**ADDENDUM
NO. 02**

**Franklin Central High School Addition and Renovations Phase 3A.1
6215 S. Franklin Rd
Indianapolis, IN 46259**

ADDENDUM NO. 2 (TWO)

DATE: March 28, 2025
PROJECT: Additions & Renovations to Franklin Central High School
Phase 3A.1
OWNER: Franklin Township Community School Corporation
PROJECT NO.: 2024040.00

Project No: 2024040.00
Project Date: FEBRUARY 27, 2025
Drawing No: **AS101**
ADD. NO. 2
(3-28-25)

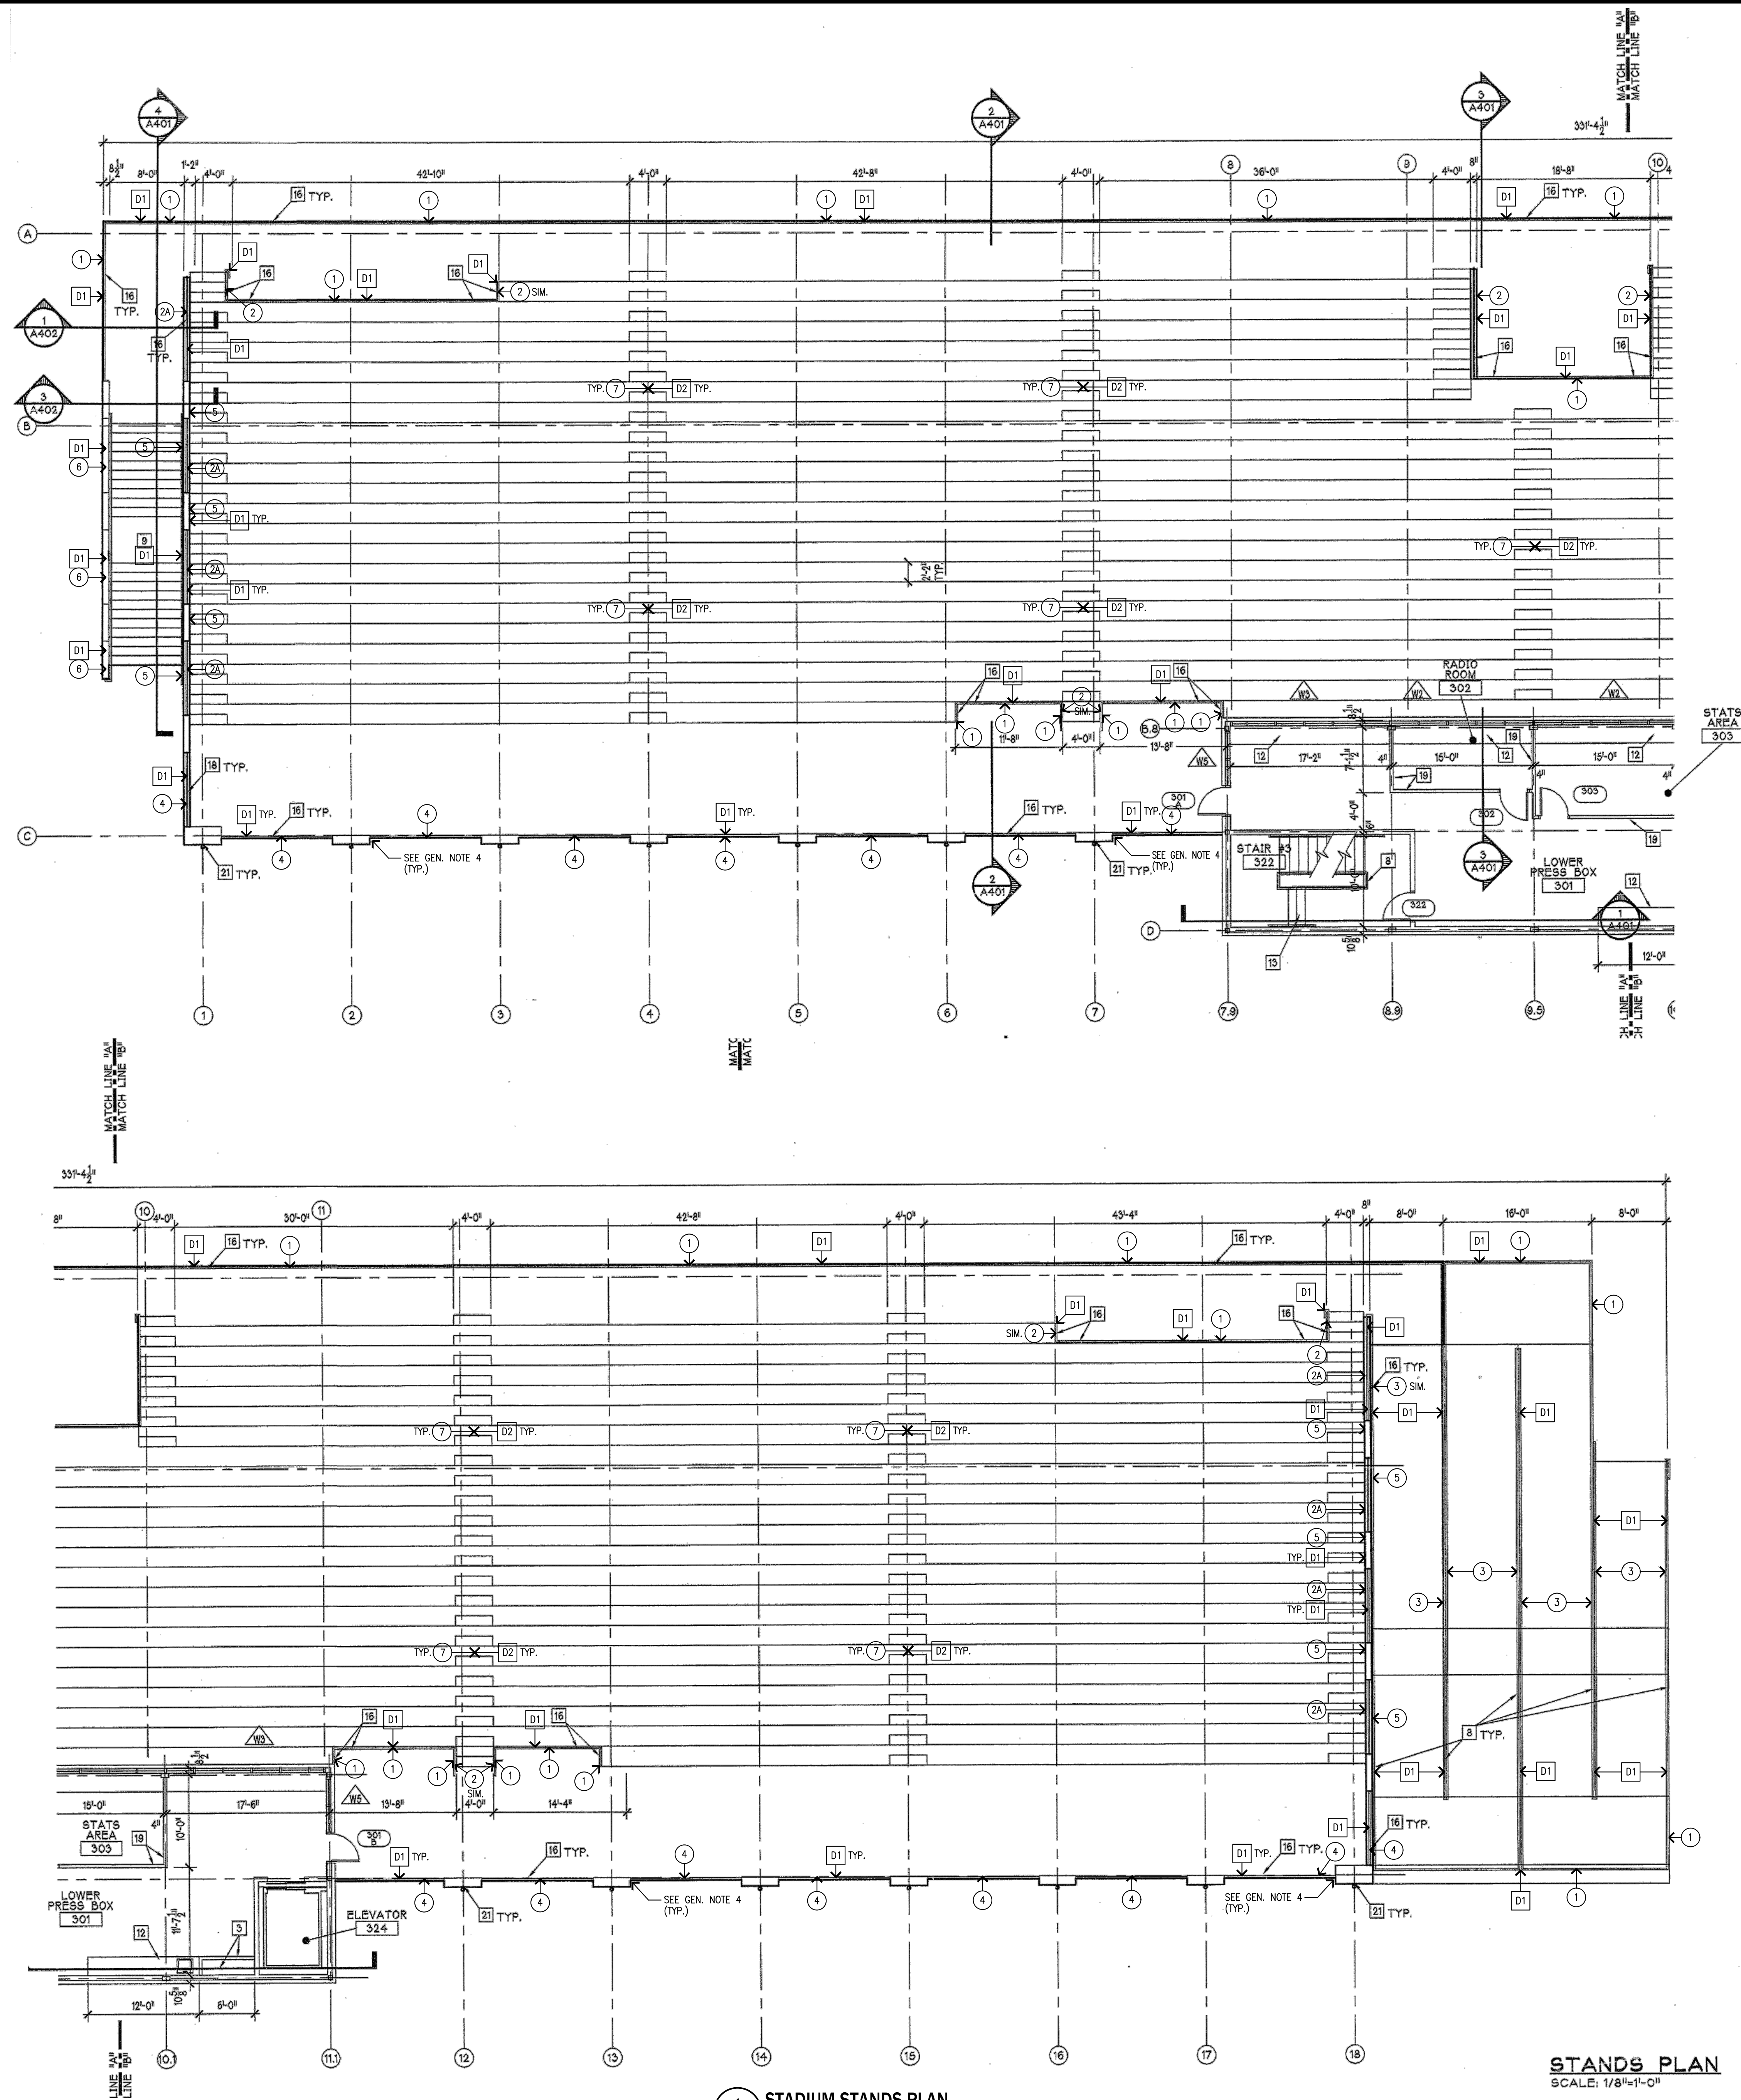
- 2-5 AS101: Add attached drawing in its entirety for Alternate No. 4 (Stadium Railings).
- 2-6 AS102: Add attached drawing in its entirety for Alternate No. 4 (Stadium Railings).

ADD2-SKS1

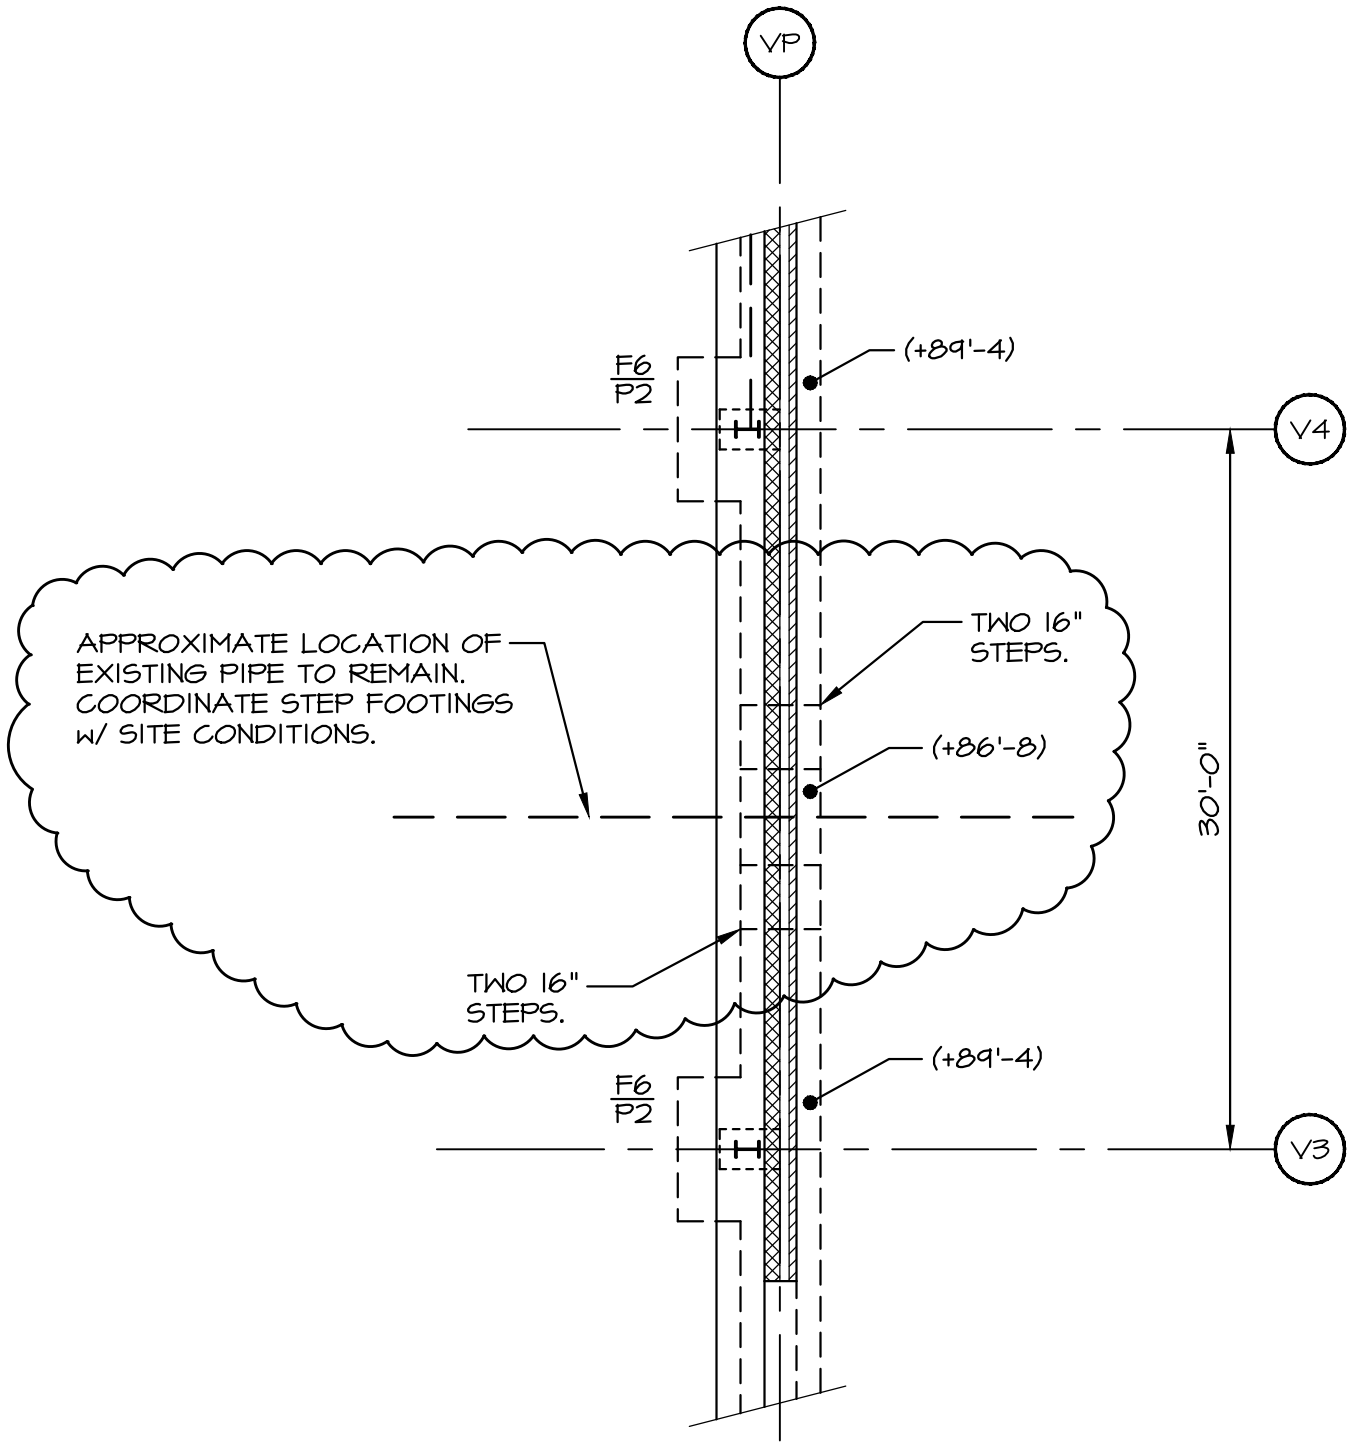
- 2-9 AS105: Add attached drawing in its entirety for Alternate No. 4 (Stadium Railings).
- 2-10 S202: Provide step footings along column line VP between column lines V3 and V4 for existing pipe that is to remain. Provide sleeve where existing pipe penetrates existing foundation wall. Coordinate location of step footings, location of existing pipe, and size of existing pipe with existing conditions. Refer to attached sketch, ADD2-SKS1.
